Addendum to GSI Typical Details

June 2023

This is an addendum to the Green Stormwater Infrastructure Typical Details Version 2.0. A previous version of this Addendum was released in December 2020. Replacement and pilot details are presented on the following pages in PDF form. Updates have been made to the CAD versions in the .zip file on the [GSI Resource Directory](#).

F-2

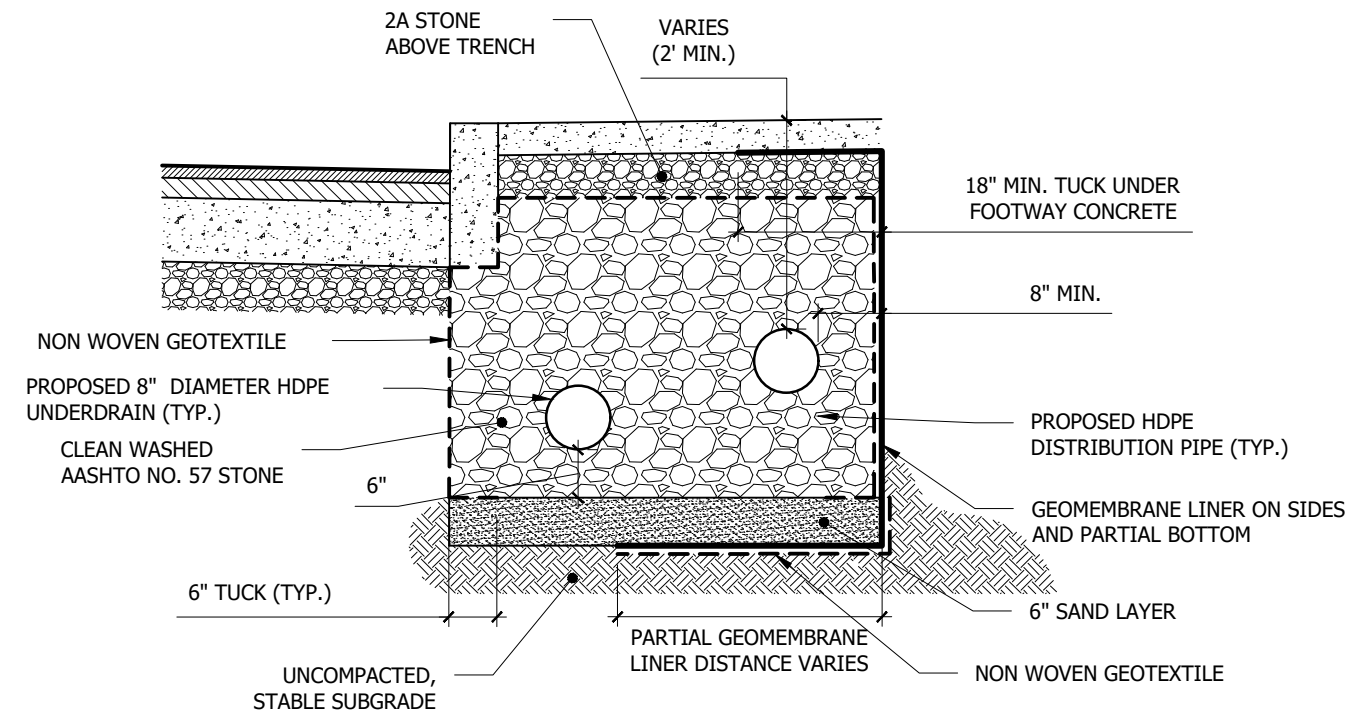
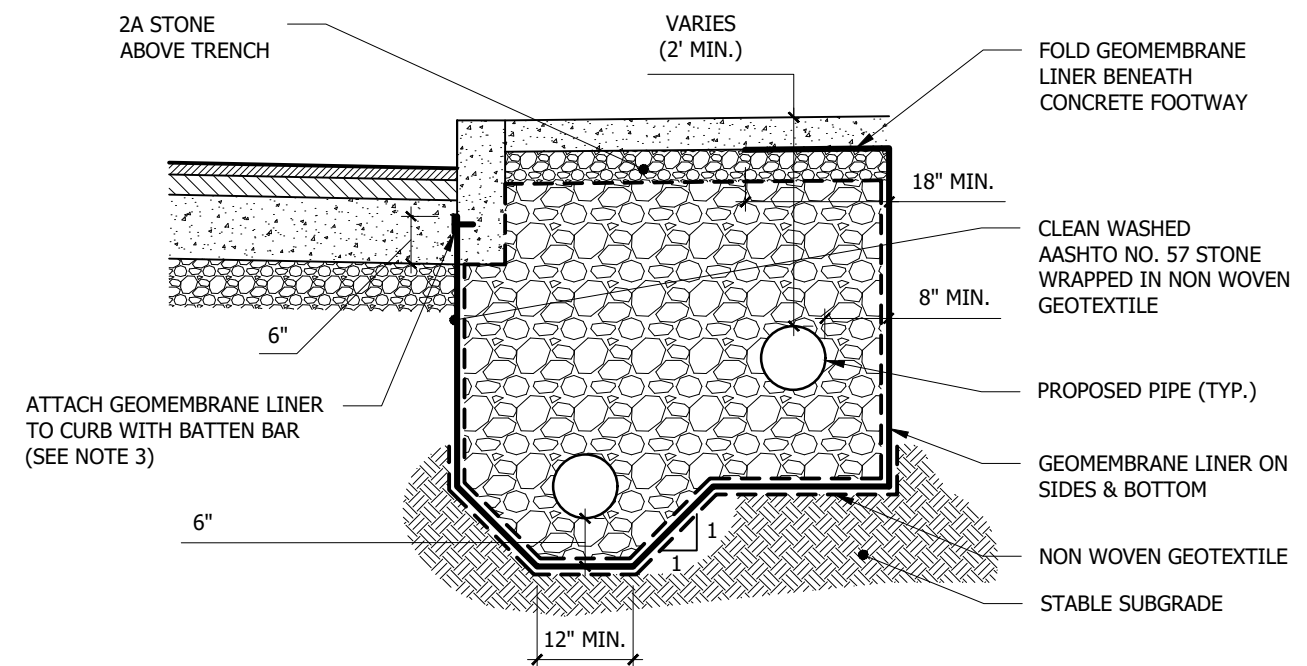
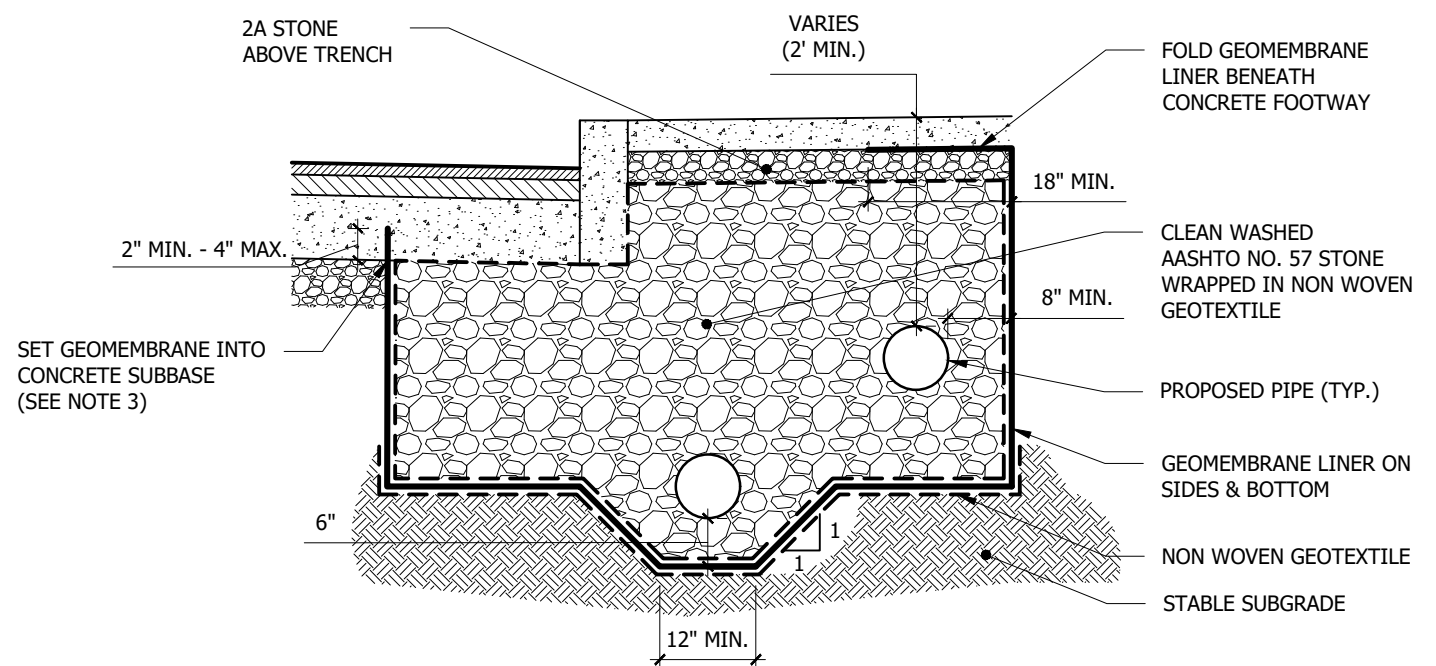
F-2 Stormwater Trench Cross Section

Updated in December 2020 to reflect latest recommended liner configurations. Added a section showing a fully lined trench extending into cartway.

VS.	DATE	INITIALS	REASON
1	06/09/2017	MJD	ADDED PARTIALLY LINED TRENCH SECTION
2	06/01/2018	MJD/DJM	CONVERTED TO FUNCTIONAL DETAIL, ADDED GEOTEXTILE AND SAND TO PROTECT GEOMEMBRANE LINER
3	12/04/2020	DJM	UPDATED GEOMEMBRANE LINER STANDARDS, ADDED FULLY LINED UNDER CARTWAY AND FOOTWAY SECTION

C-2

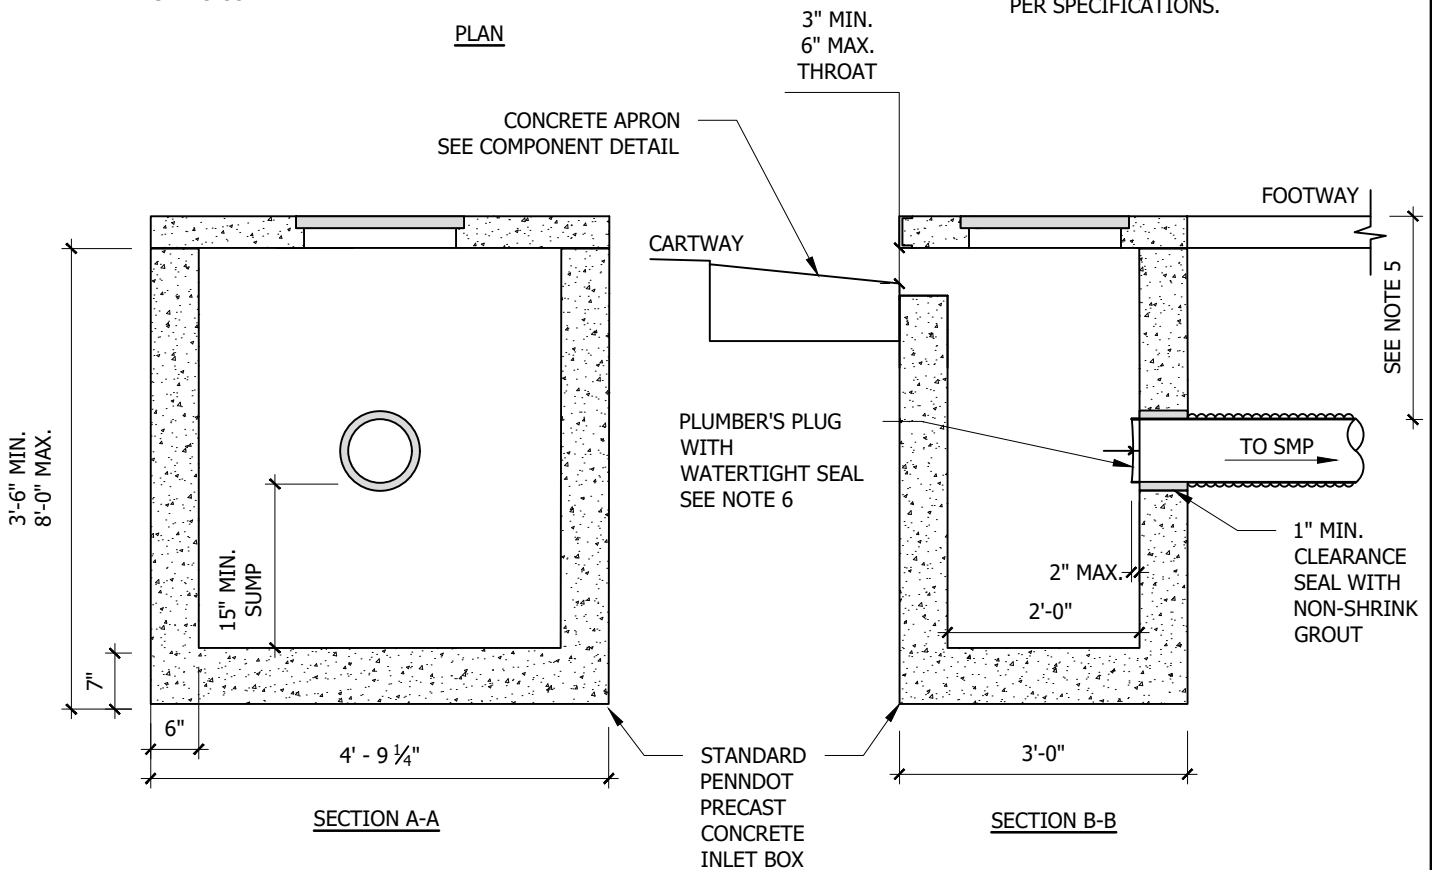
C-2 Green City Inlet

Update released in January 2020. Removed trash guard due to updated inlet protection requirements in specifications.

VS.	DATE	INITIALS	REASON
1	06/09/2017	DJM	
2	06/01/2018	ANJ/DJM	ADDED MARKER, CLARIFIED OPEN MOUTH FORMATION
3	01/30/2020	DJM	REMOVED TRASHGUARD, ADDED INLET PROTECTION NOTE

TRENCH DRAIN			
VS.	DATE	INITIALS	REASON
1	09/01/2016	ANJ/DJM	
2	06/01/2018	MJD/DJM	EXTENDED 6" PAST SIDEWALK, UPDATED CURB APRON
3	12/10/2020	DJM	UPDATED CURB OPENING, CHANNEL, ENERGY DISSIPATER
4	06/30/2023	VJF/DJM	CHANGED TO 4' CITY INLET TOP SLAB OVER CURB OPENING

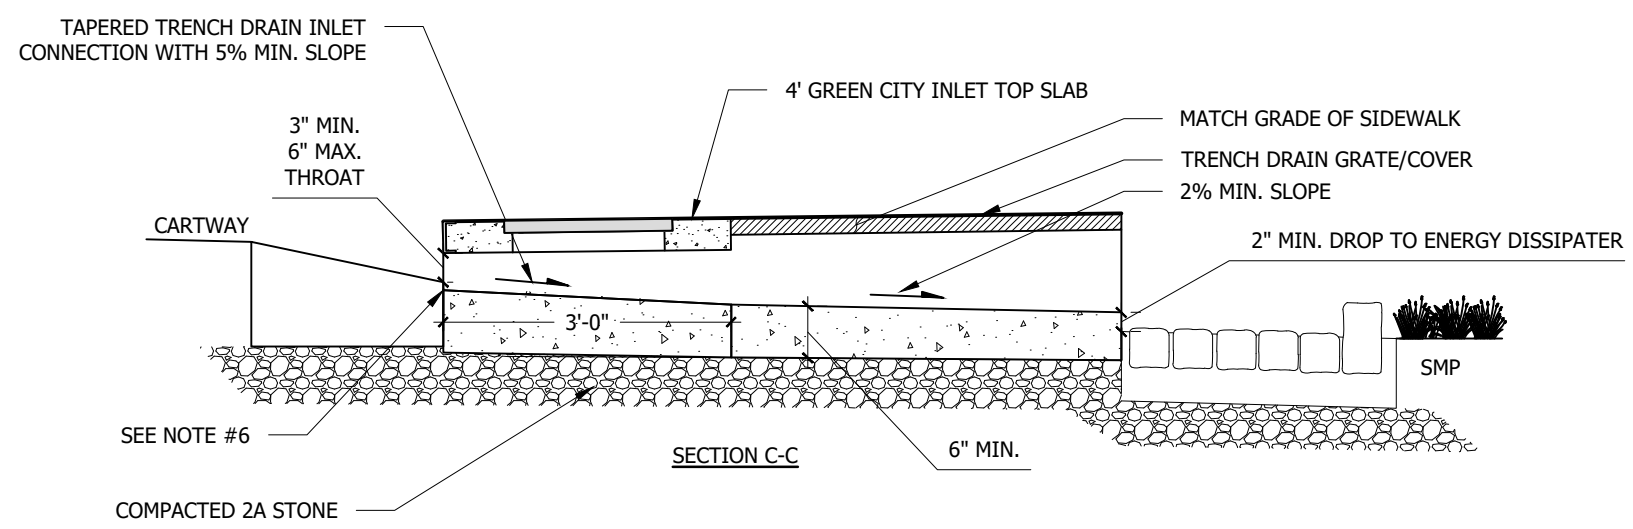
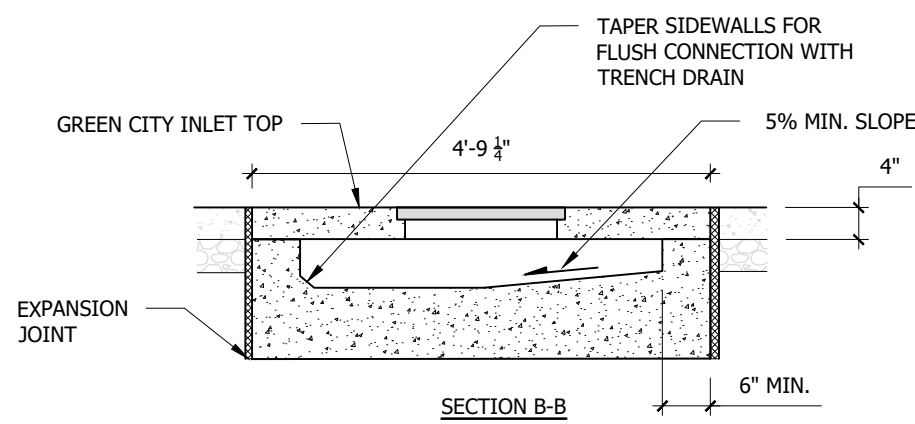
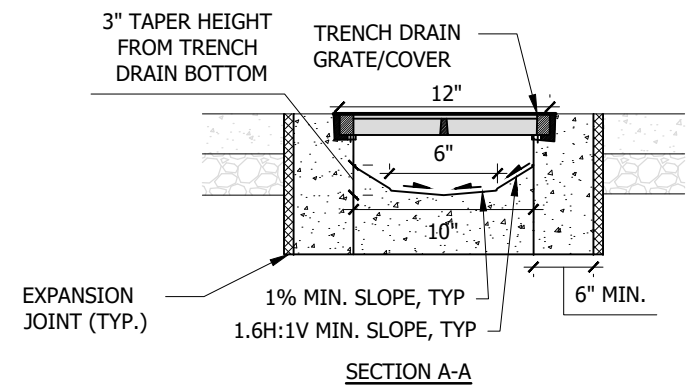
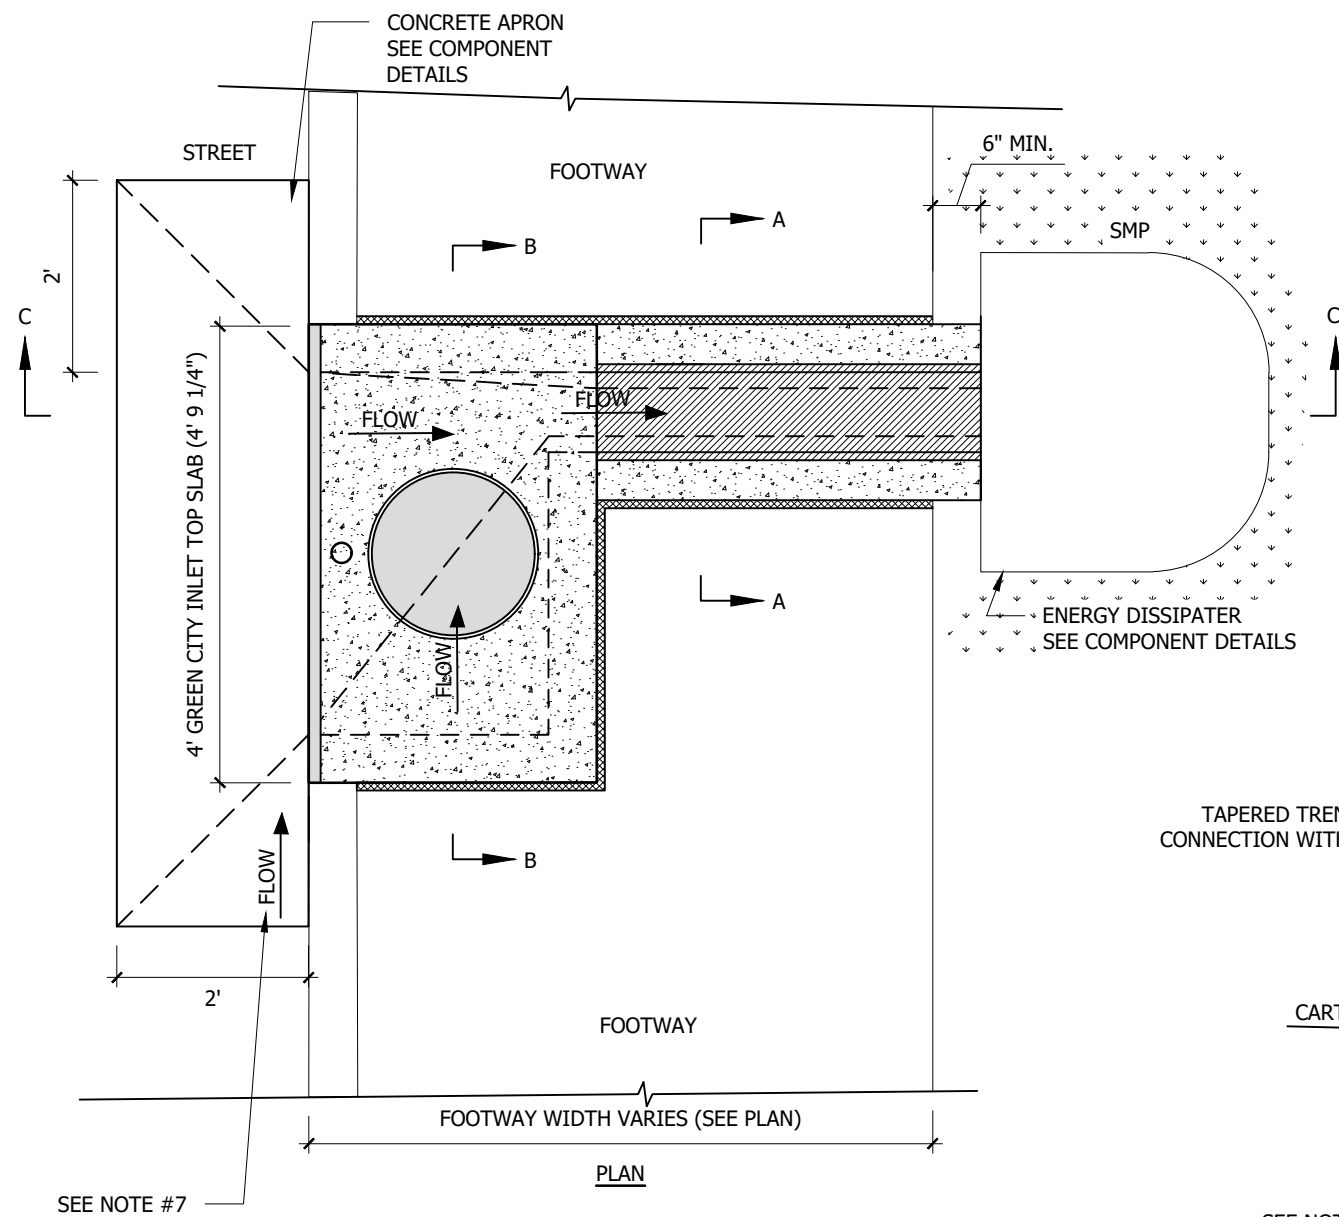
C-5 Trench Drain

In December 2020, added standardized curb opening and modified channel configuration for better runoff capture and maintainability. Updated in 2023 with precast concrete curb opening top rather than cast iron.

DRAWING NUMBER:
C-10

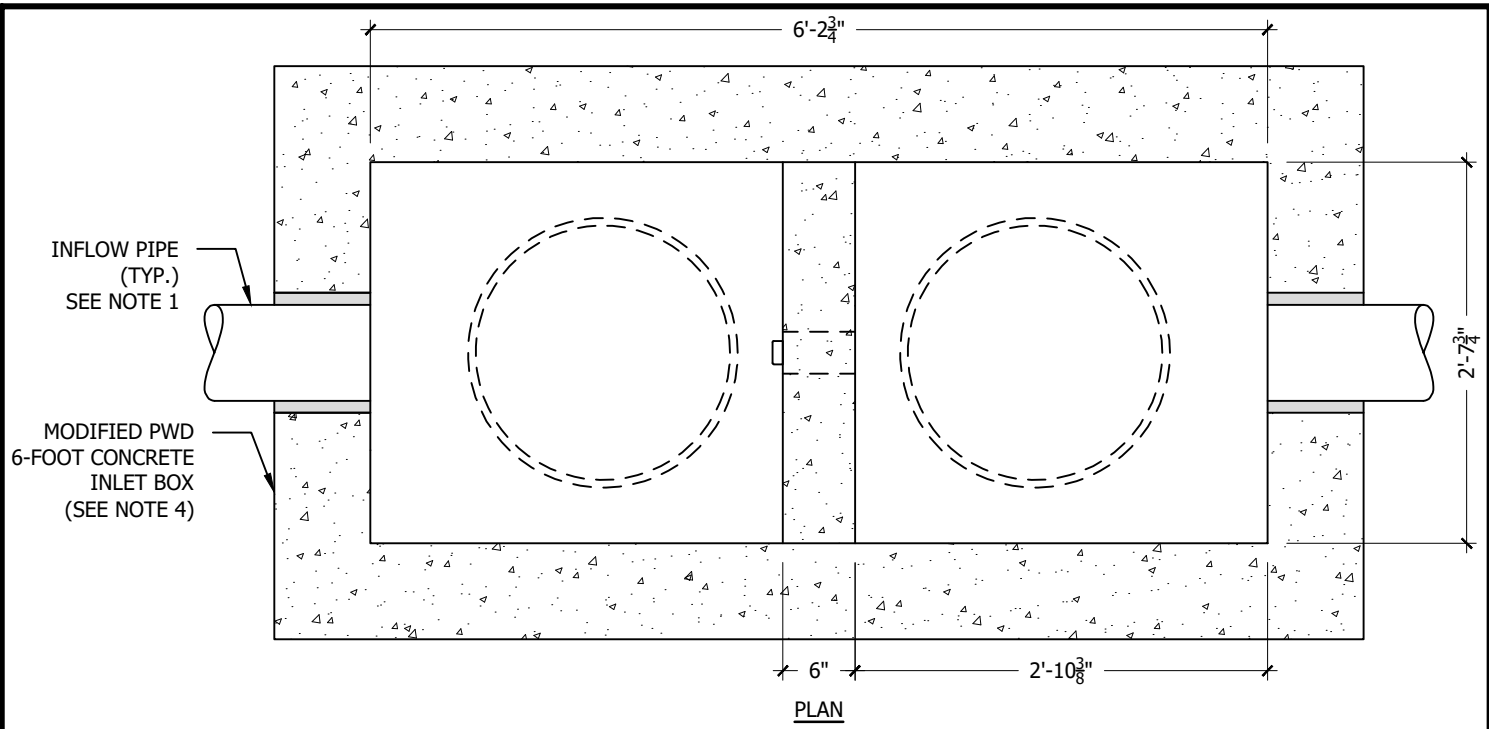
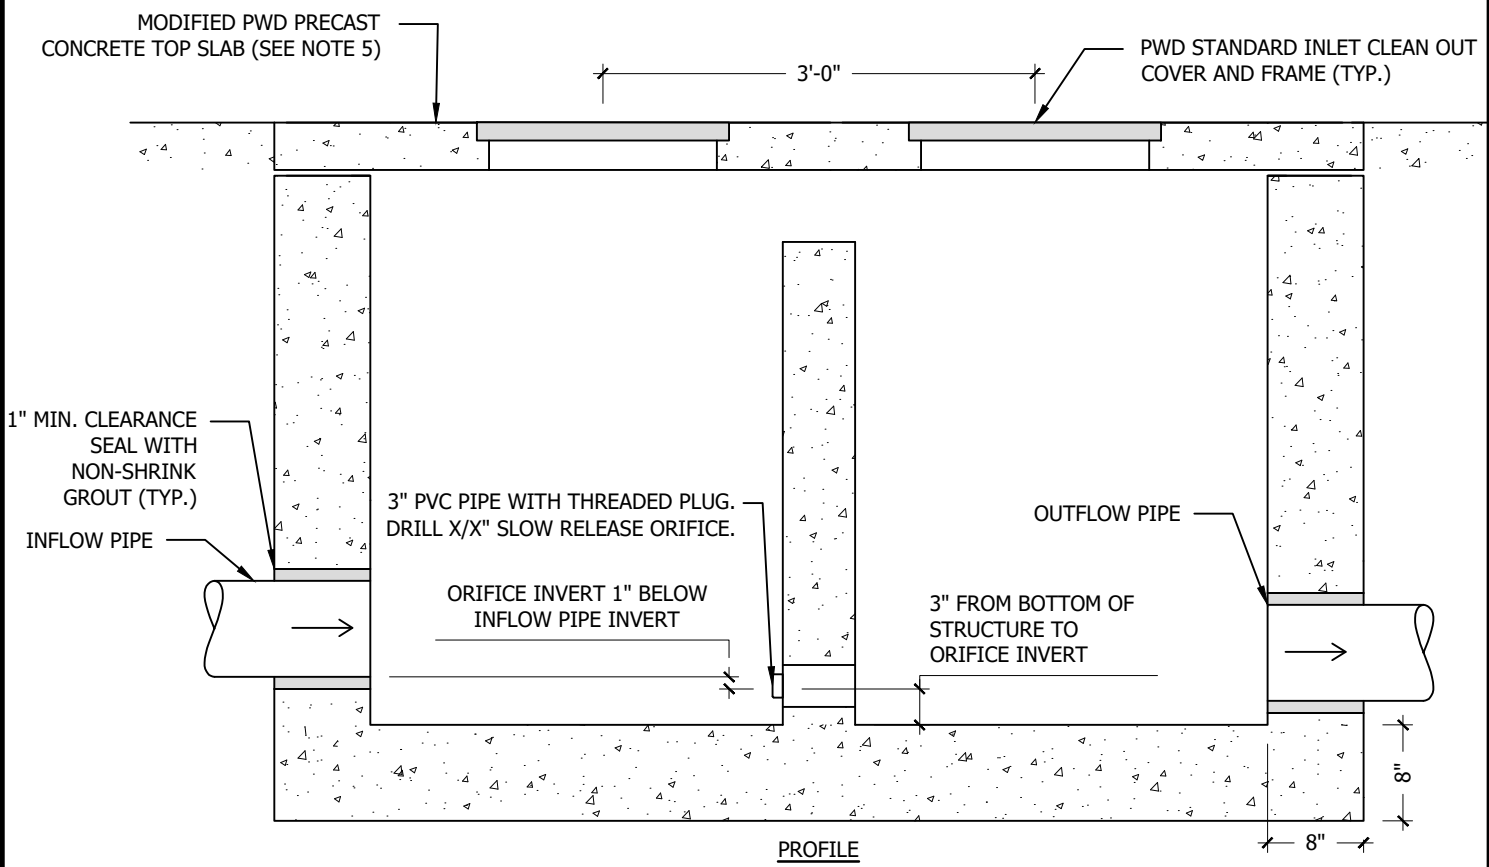
C-10 Water Level Control Structure

In December 2020, enlarged box to allow greater maintenance access and constructability.

VS.	DATE	INITIALS	REASON
1	06/09/2017	MJD	UPDATED BOX, WEIR, FRAME AND GRATE
2	06/01/2018	ANJ	ADDED NOTE 3
3	12/10/2020	DJM	CHANGED TO 6' BOX
